**MOORE PUBLIC SCHOOLS -
HIGHLAND EAST JUNIOR HIGH SCHOOL
STEM ADDITION**

ADDENDUM NO. 1

January 26, 2022

2
ELEVATION @ TYP. LAB
1/4" = 1'-0"

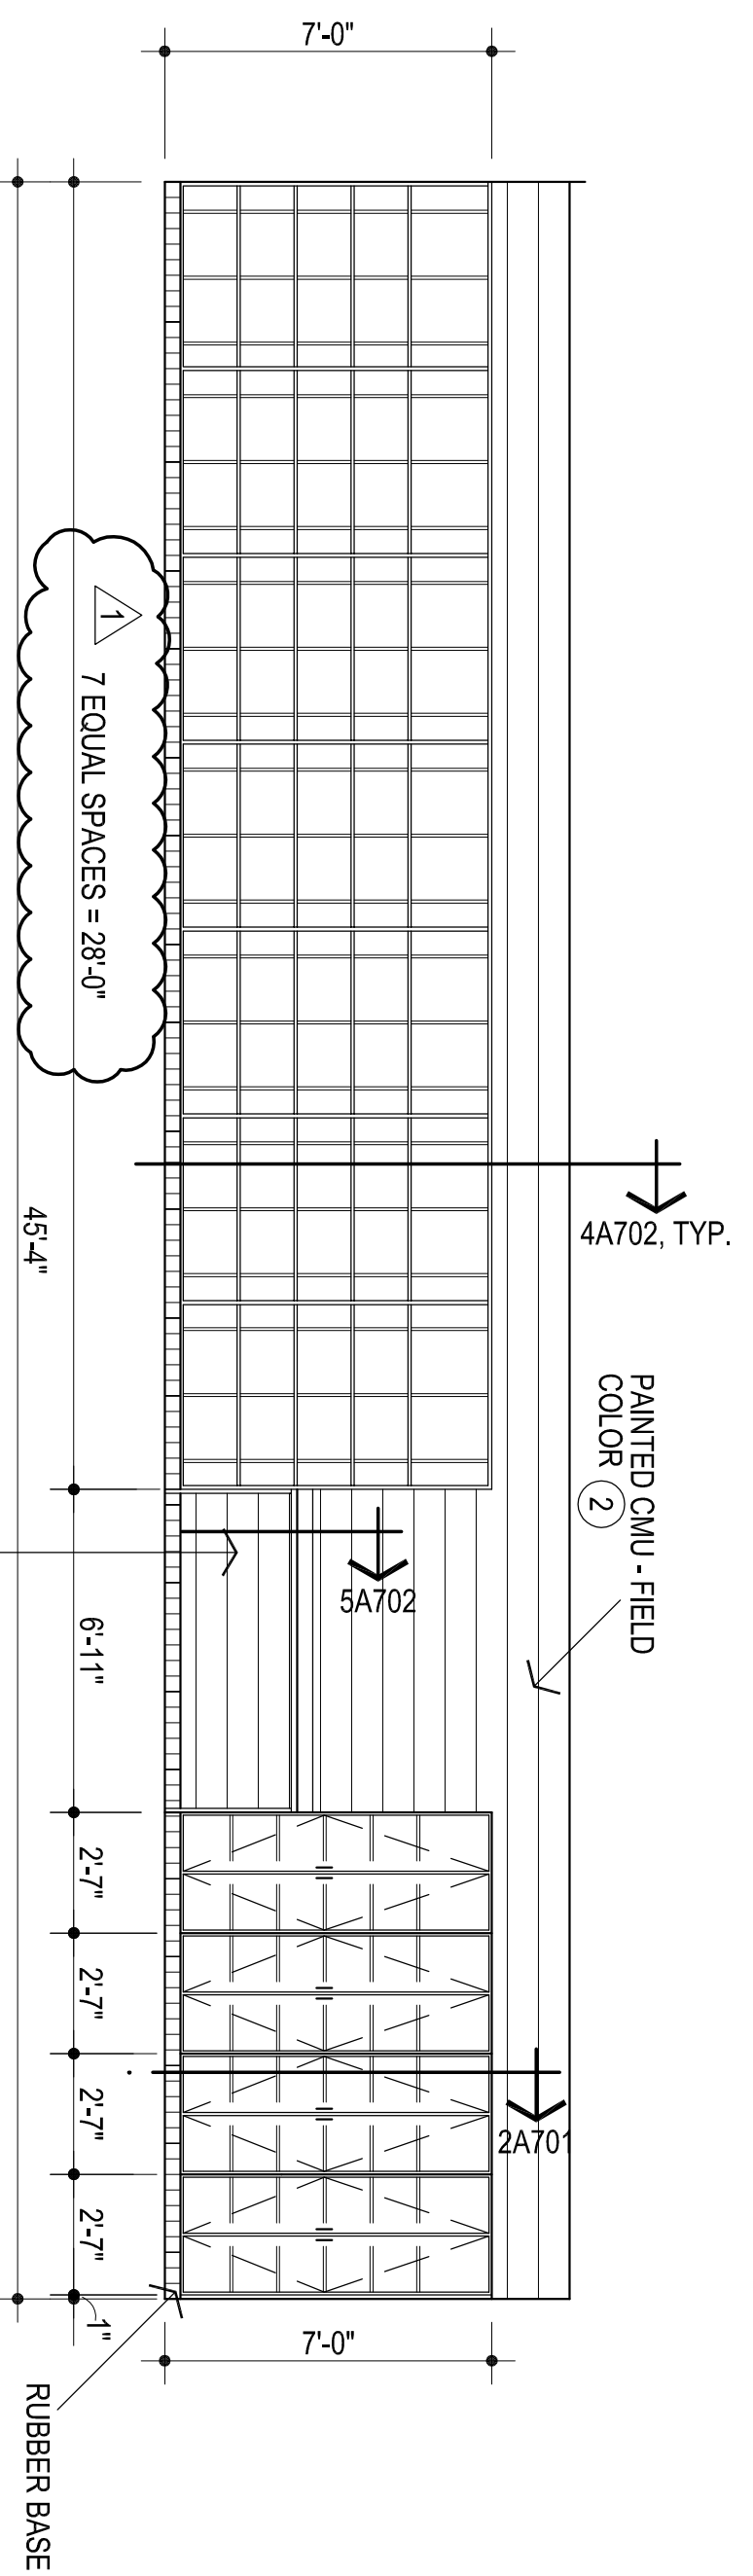
1. Sheet A103, Detail #1, Floor Plan: revise interior elevation referencing in Rooms #17, 22, and 26 as per attached revised drawing.
2. Sheet A401, Detail #2, Elevation at Typical Lab: revised number of equal spaces for shelving to "7 spaces" in lieu of six as indicated. Refer to attachment.
3. Sheet A501, Detail #20, Plan Detail and Sheet 601, Detail #2, Color Schedule: refer to attached Request for Information #2 for clarifications.

1 FIRE PROTECTION PLAN
1/8" = 1'-0"

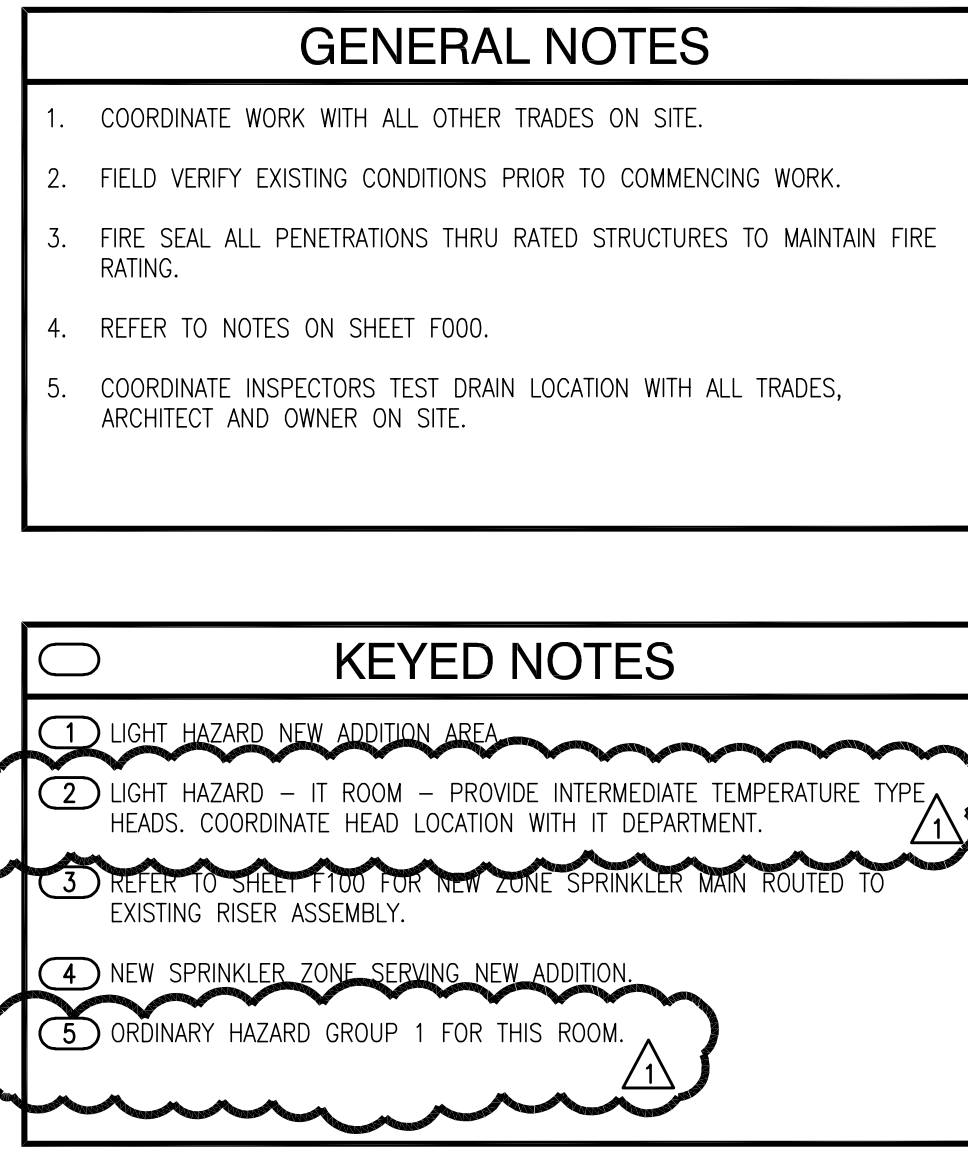
- Add Keyed Note 5 to change Storage, Mech/Elec and Custodian rooms to type Ordinary Hazard Group 1.
 - Revise Keyed Note 2 to provide intermediate temperature sprinkler head in IT room.

Date	January 24 th , 2022
Project	Highland East Junior High Classroom Addition
Subcontractor / Supplier	
	Address:
Manufacturer	
Spec. Section	Bid Package 12 Section
Notes Below	
<p>Clay / Mike please see the RFI #4 request below .</p> <p>Thanks</p> <p>Has the owner decided what type of fire protection they want in the IT room per note 2 on Fire Protection Sheet F101?</p> <p>What type of laboratories are we looking at? Chemistry, Biology, Computer? If Chemistry or Biology, will there be any flammable chemicals and will Bunsen burners be utilized?</p> <p>Sheet F101 says all rooms are light hazard. However, there are a few storage rooms and a custodian room that should be classified Ordinary. Please clarify.</p> <p>Salas O'Brien Response:</p> <ol style="list-style-type: none">1. Provide intermediate temperature sprinkler head – Refer to Addendum 1.2. Laboratories are computer type therefore no flammable chemicals or Bunsen burners.3. Storage rooms, Mech/Elec room and Custodian room shall be changed to type Ordinary Hazard group 1 – Refer to addendum 1. <p>Kevin Parsons Salas O'Brien 1/24/2022</p>

- (1) LIGHT HAZARD - NEW ADDITION AREA.
- (2) LIGHT HAZARD - IT ROOM - PROVIDE INTERMEDIATE TEMPERATURE TYPE HEADS. COORDINATE HEAD LOCATION WITH IT DEPARTMENT.
- (3) REFER TO SHEET F100 FOR NEW ZONE SPRINKLER MAIN ROUTED TO EXISTING RISER ASSEMBLY.
- (4) NEW SPRINKLER ZONE SERVING NEW ADDITION.
- (5) ORDINARY HAZARD GROUP 1 FOR THIS ROOM.
